Safety Evaluation Report for an Early Site Permit (ESP) at the North Anna ESP Site

U.S. Nuclear Regulatory Commission
Office of Nuclear Reactor Regulation
Washington, DC 20555-0001

September 2005

Figure 2.4.3-2 Inflow and outflow hydrographs for North Anna reservoir during the PMF event

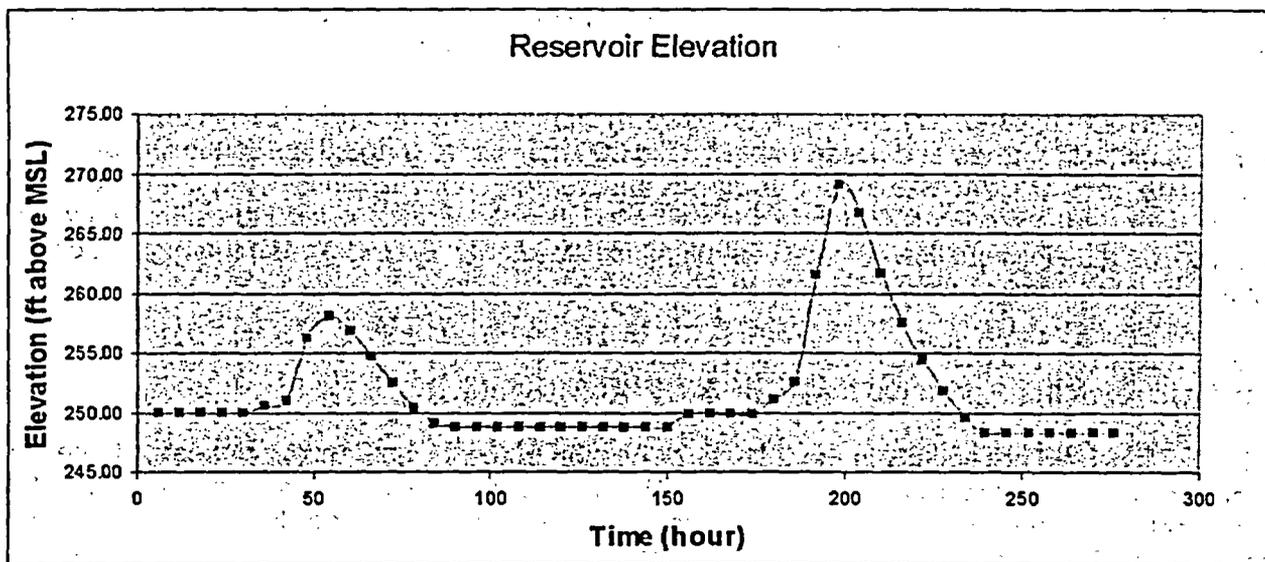
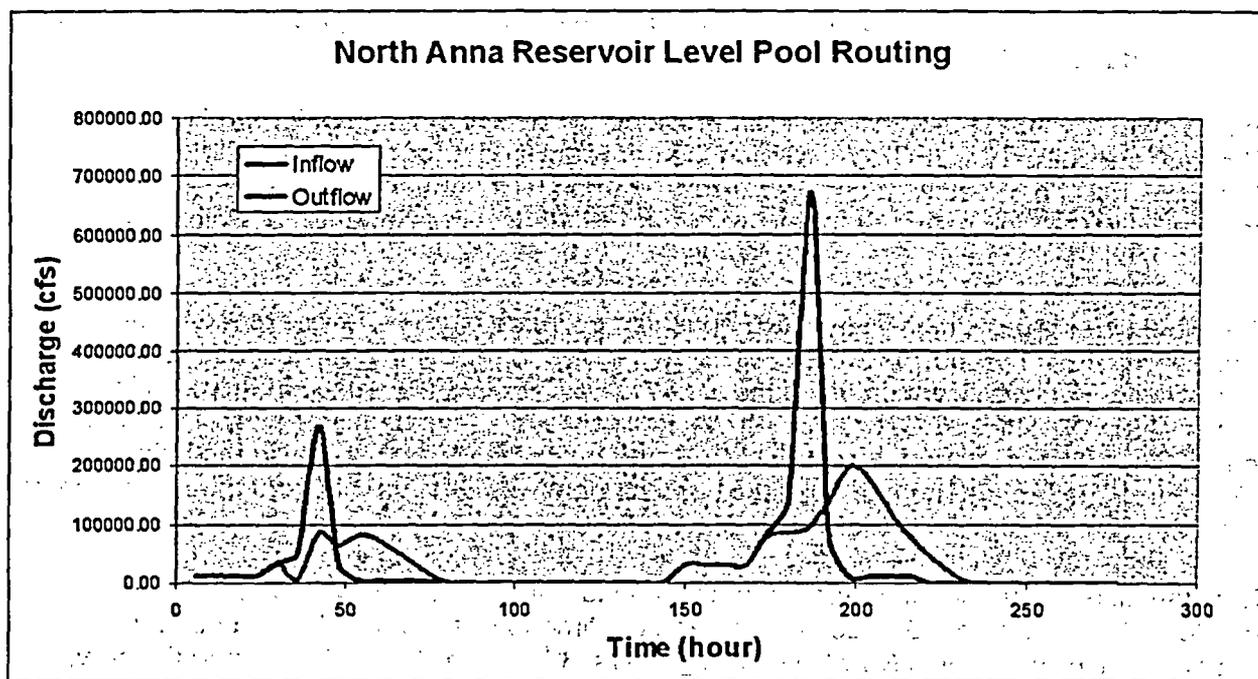
The next approach the staff used was to route the staff-estimated PMF (column 3 of Table 2.4.3-4), assuming no precipitation loss and instantaneous translation, through Lake Anna using level pool routing (Linsley, et al., *Hydrology for Engineers*, 1982, p. 272). This second approach resulted in the reservoir inflow-outflow sequence shown in Figure 2.4.3-2. Figure 2.4.3-3 depicts the corresponding reservoir elevations. The staff used the following reservoir operation rules during the PMF event—(1) operate the spillway gates, if reservoir elevation is at 250 ft MSL, to let all inflow pass through, and (2) raise reservoir gates gradually when reservoir elevation exceeds 250 ft MSL to allow more discharge, depending on the reservoir elevation, until water is freely discharged over the spillways.

analysis from the applicant to independently estimate floodwater level at the ESP site, as discussed below.

Figure 2.4.3-4 Applicant's original (black line) and staff's conservative (red line) unit hydrographs

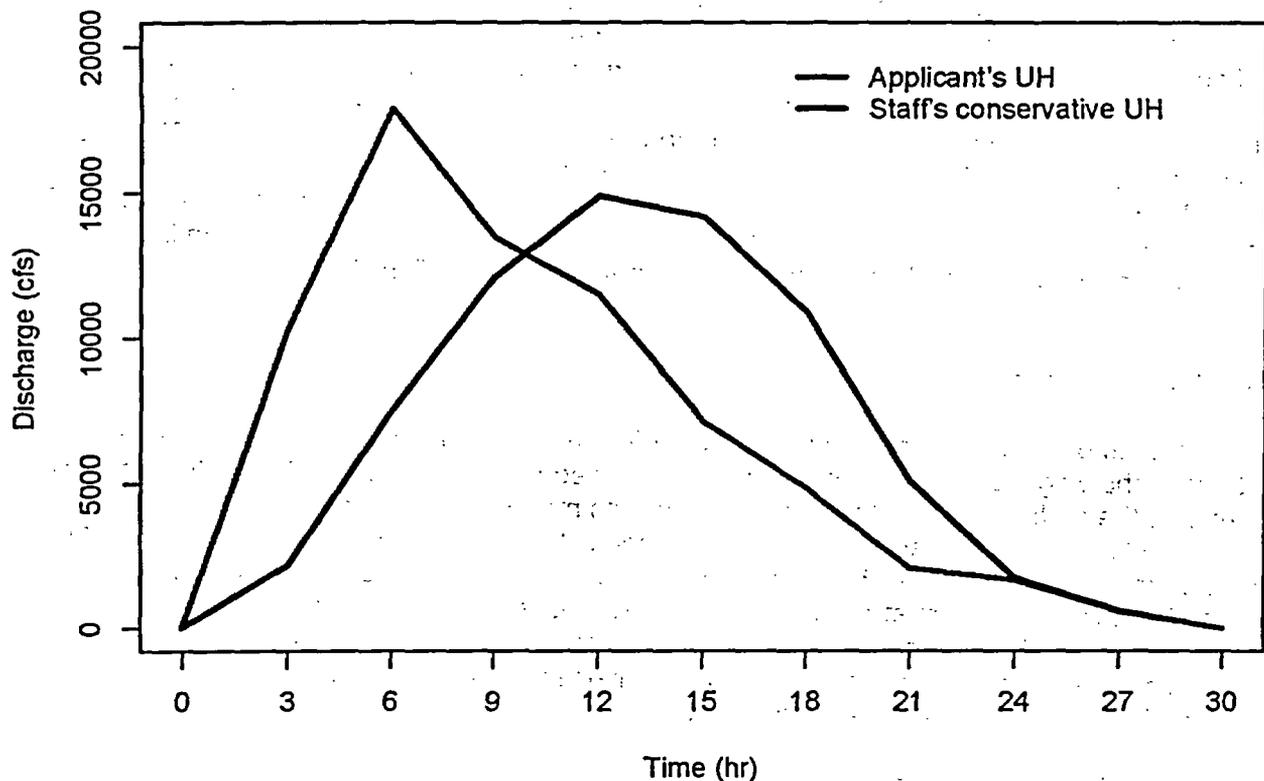
The staff also determined that, for computing floods from PMP, unit hydrograph flood peaks should be increased from 5 to 20 percent, and the time to peak should be reduced by 33 percent (Linsley, et al., *Hydrology for Engineers*, 3rd Edition, 1982; Pilgrim and Cordery, "Flood Runoff," Chapter 9 in *Handbook of Hydrology*, 1992). The staff adjusted the applicant's unit hydrograph according to these guidelines to provide a more conservative estimate of the unit hydrograph than that used by the applicant. Figure 2.4.3-4 illustrates the staff's conservative and the applicant's original unit hydrographs. The peak discharge in staff's conservative unit hydrograph is 20 percent greater than that in applicant's unit hydrograph, and

the time to peak in staff's conservative unit hydrograph is reduced by 50 percent compared to that in applicant's unit hydrograph.

The staff also conservatively assumed that no infiltration losses occurred during the PMP event. The staff modified the applicant's HEC-1 input file and carried out another HEC-1 run using the conservative unit hydrograph and no infiltration loss. This run resulted in a peak inflow of 342,502 cfs and a corresponding peak discharge of 143,775 cfs. The maximum calculated water surface elevation at the dam was 264.6 ft MSL.

Figure 2.4.5-1 North Anna Power Station site and fetch length

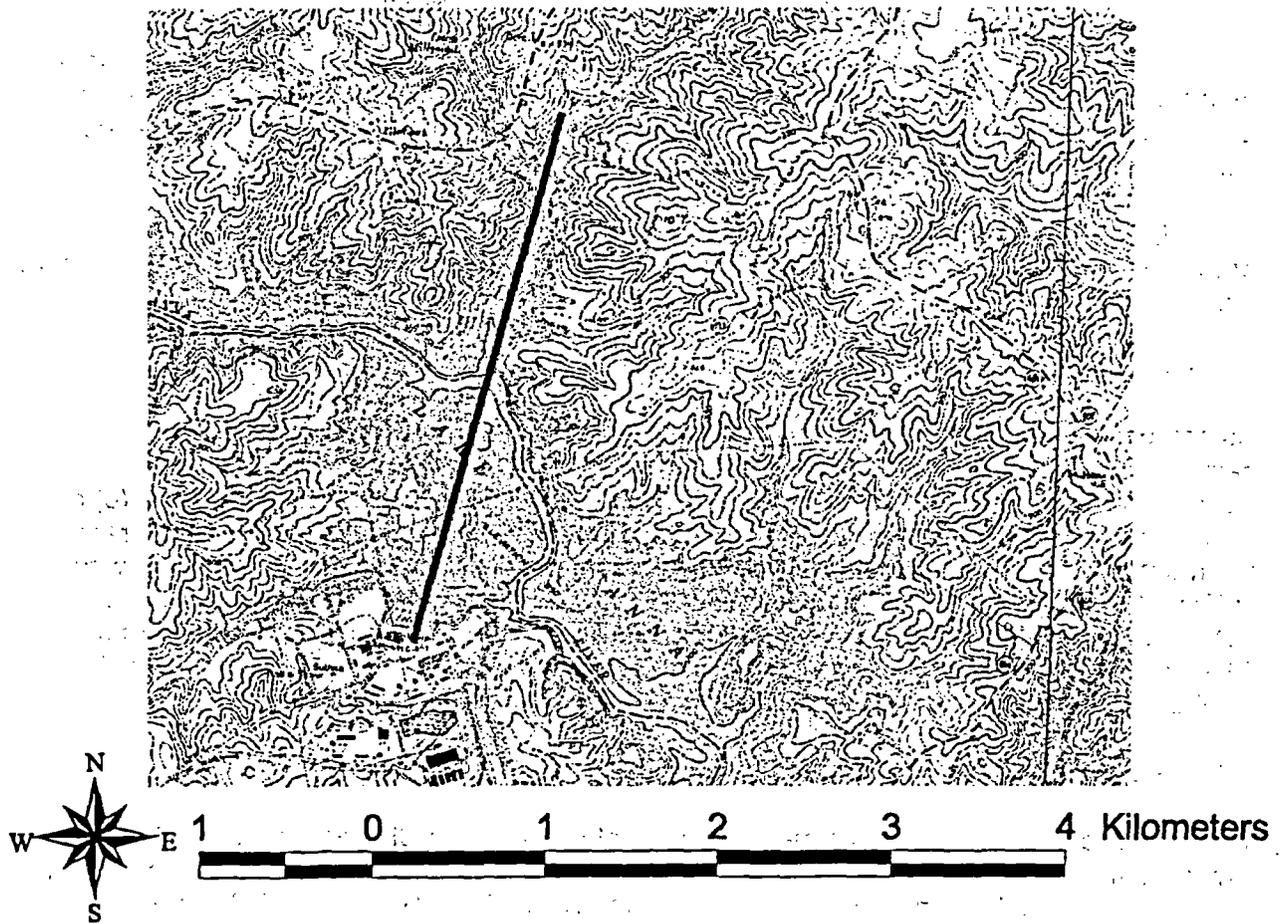
The following describes the staff's independent evaluation to estimate seiche effects. Fetch length is one of the key parameters for determining wind setup, and it is generally based upon the longest straight-line distance to the opposing shore. Although the ESP site is 5 miles from the North Anna Dam and more than 10 miles from the upstream end of the reservoir, the longest straight-line distance to the opposing shore is approximately 2 miles (see Figure 2.4.5-1).

The staff estimated the period of oscillation caused by seiche along the fetch length line shown in Figure 2.4.5-1 based on the theory for free oscillation of water of uniform depth in a rectangular basin (Wilson, "Seiches," *Advances in Hydroscience*, Volume 8, 1972):

Figure 2.4.6-1 Landslide diagram resulting in wave traveling towards the ESP site. The 70 ft segment indicated in blue is the distance from the shore to the thalweg and represents that part of the water column displaced by the landslide.

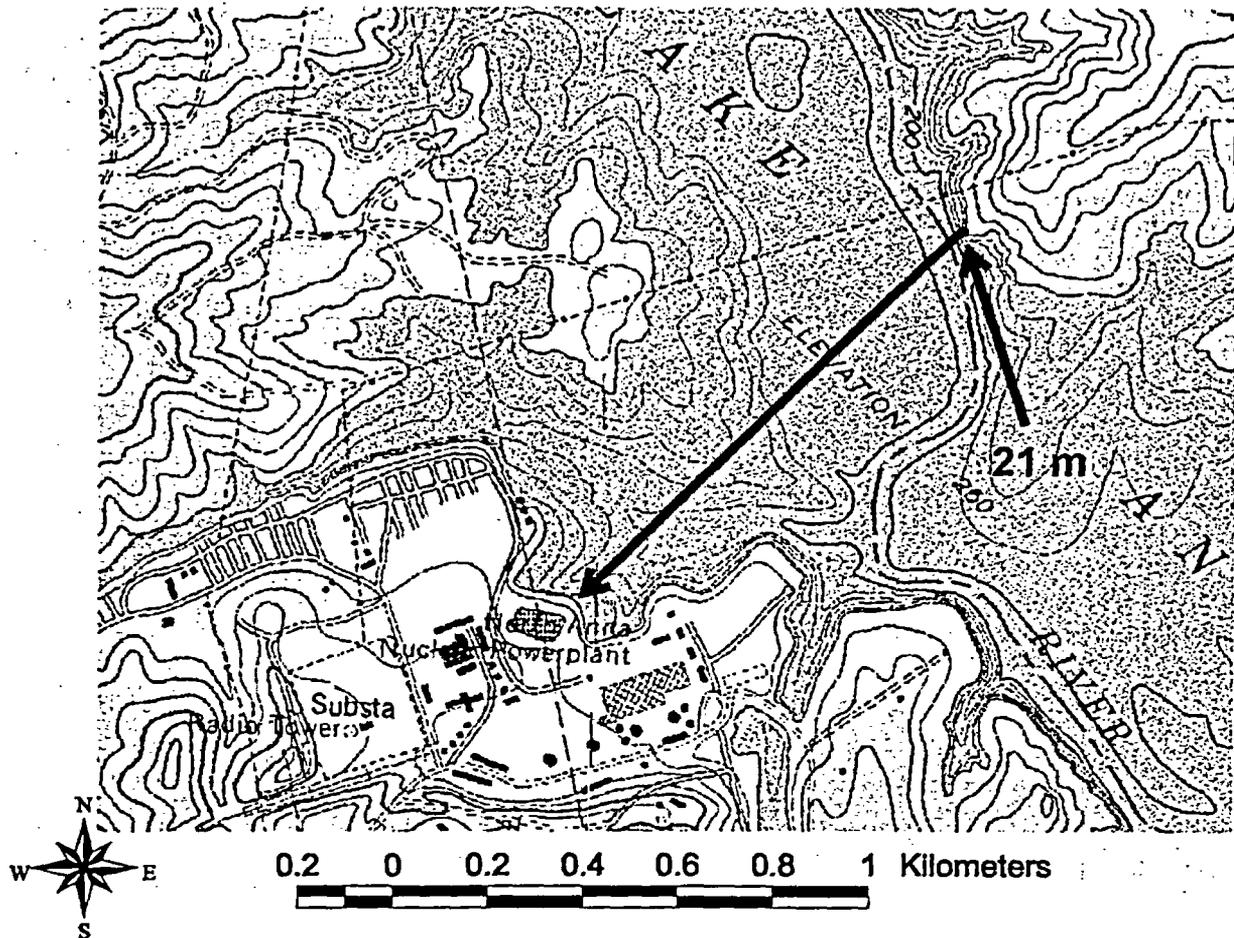
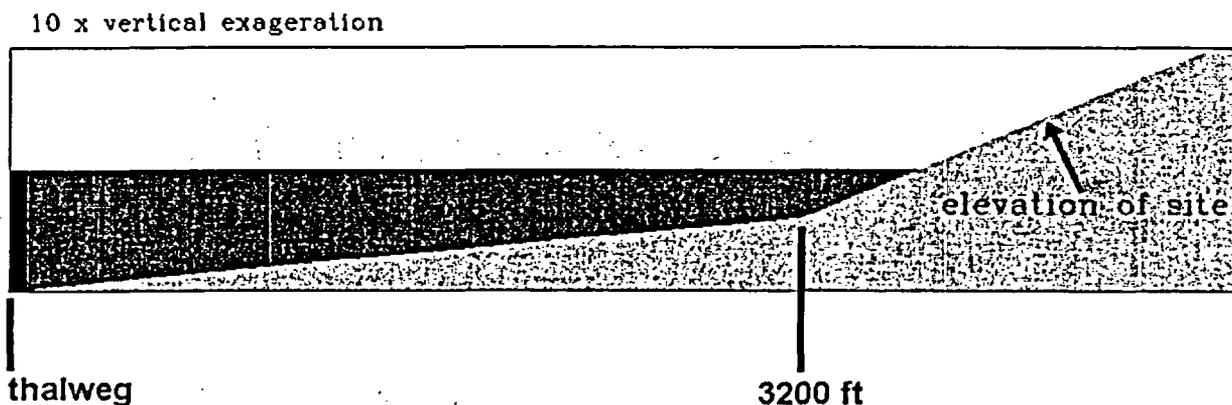
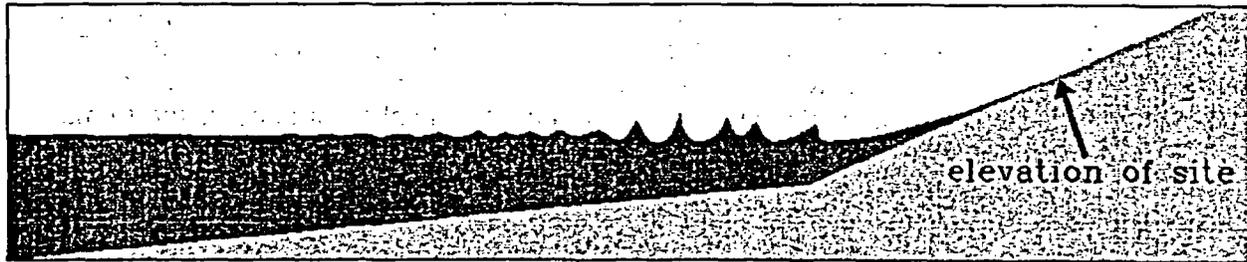
level in Lake Anna, a landslide could therefore fall 50 ft before hitting the water. If drag is neglected, an object falling from the hilltop could reach a vertical speed of approximately 55 ft/s. The staff conservatively assumed that such a hillslope failure might result in a horizontal water wave of the same speed. In addition, the staff conservatively assumed that this landslide would displace water from the existing shoreline to the deepest portion of the lake approximately 70 ft offshore (see Figure 2.4.6-1).

The staff initialized the numerical model with a 70-ft horizontal zone with a horizontal velocity of 55 ft/s, while the remainder of the lake was quiescent (see Figure 2.4.6-2). The staff assumed the boundary condition at midlake to be a wall that caused outgoing waves to reflect back towards the ESP site. The boundary condition on top of the domain was gauge (atmospheric) pressure.

The highest extent of the wave runup was reached after approximately 118 seconds and resembled a thin jet traveling up the smooth beach slope (see Figure 2.4.6-3). The highest extent of wave runup on the bank was just below an elevation of 270 ft MSL, and the water did not reach the elevation of the ESP site. At an elevation of 270 ft MSL, the wave was less than 1 ft thick. The wave reached 2 ft in thickness at an elevation of 260 ft MSL, which was 11 ft lower than the elevation of the ESP site.

Therefore, the staff concluded that, even under conservative conditions of flooding generated by severe landslide, the ESP site would remain dry.

Figure 2.5.2-6 (SSAR Figure 2.5-48A) Selected Horizontal and Vertical Response Spectra for the Hypothetical Rock Outcrop Control Point SSE at the Top of Zone III-IV Material

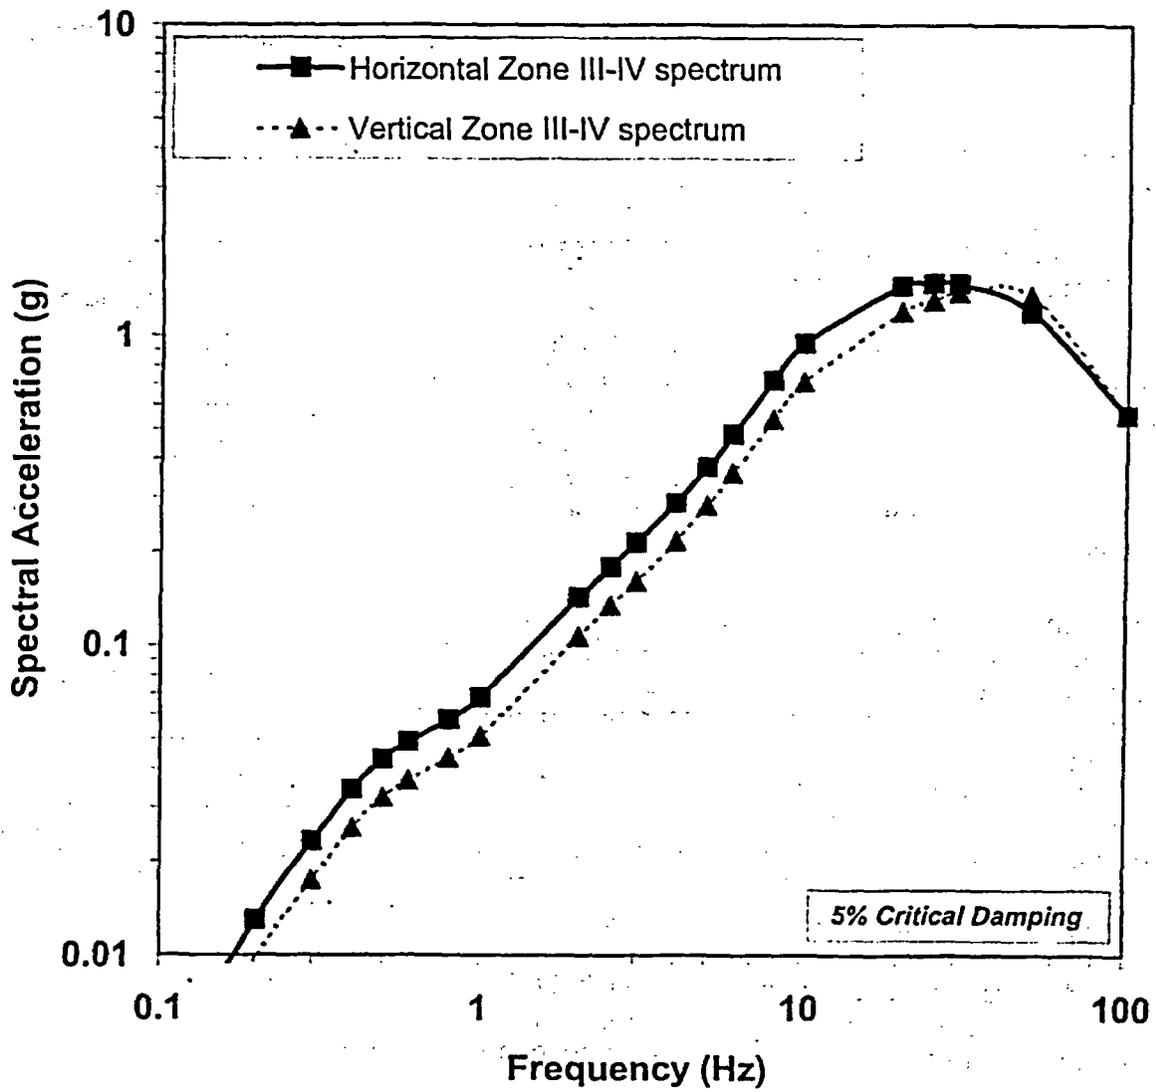
The applicant performed two sensitivity studies to demonstrate the appropriateness of the final SSE shown in Figure 2.5.2-6.

Figure 2.5.2-7 Regional seismicity for ESP site

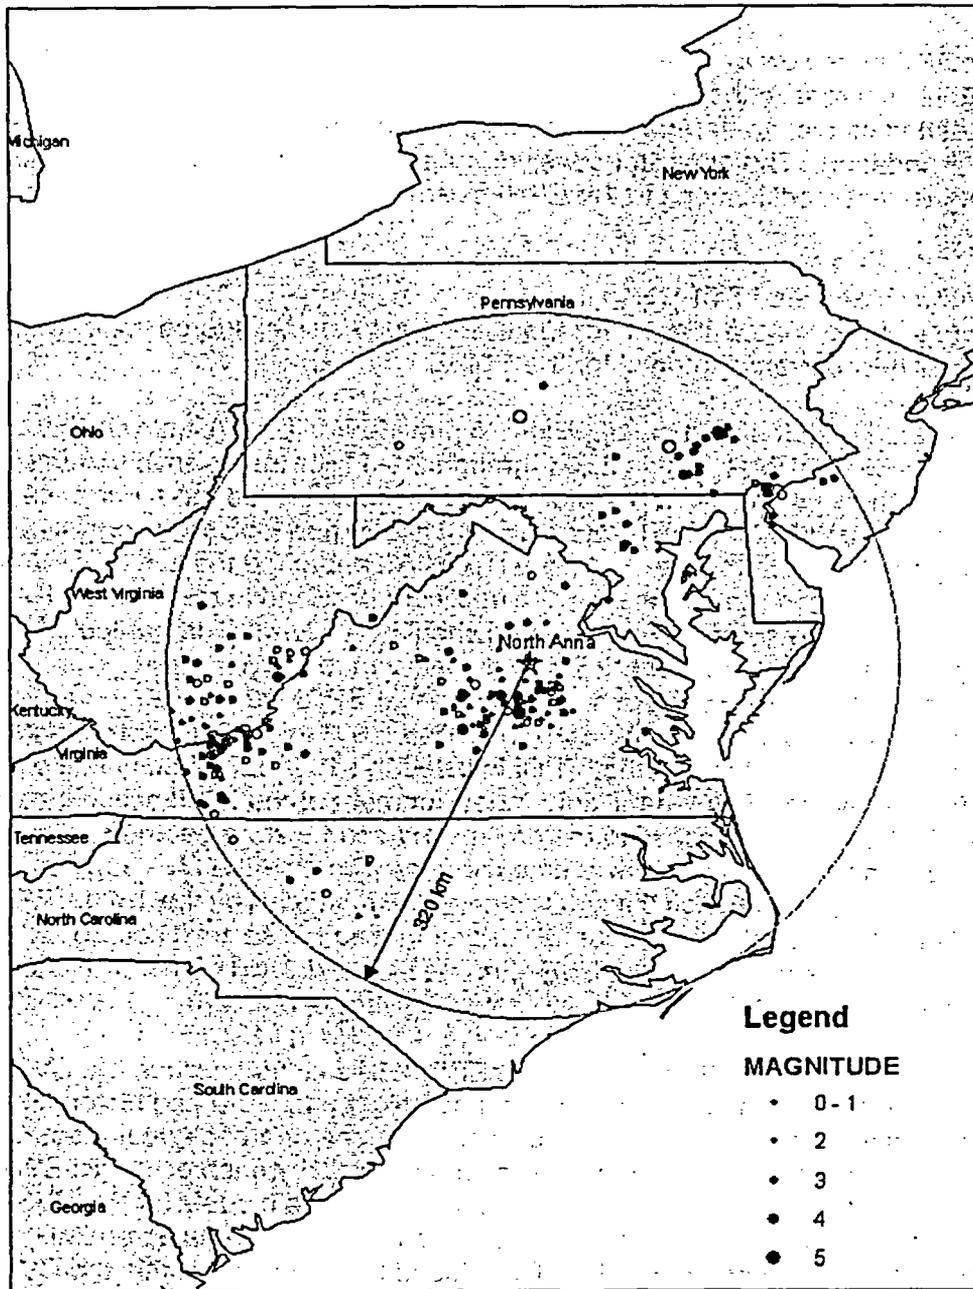
The staff reviewed both the original EPRI seismicity catalog and the update to the catalog. The applicant added 30 more earthquakes to the regional catalog for the ESP site. Figure 2.5.2-7 depicts the earthquake epicenters in the region surrounding the ESP site. The more recent events since 1984 are shown as solid dots. The cluster of seismicity to the south-southwest of the ESP site is from the CVSZ.

Because the applicant used the EPRI seismicity catalog, which is part of the 1989 EPRI seismic hazard study that the NRC endorsed, the staff concludes that the seismicity catalog used by the applicant is complete and accurate through 1984. The staff compared the applicant's update of the regional seismicity catalog with its own listing of recent earthquakes and did not identify any significant omissions. Accordingly, the staff concludes that the applicant accurately updated the regional seismicity.
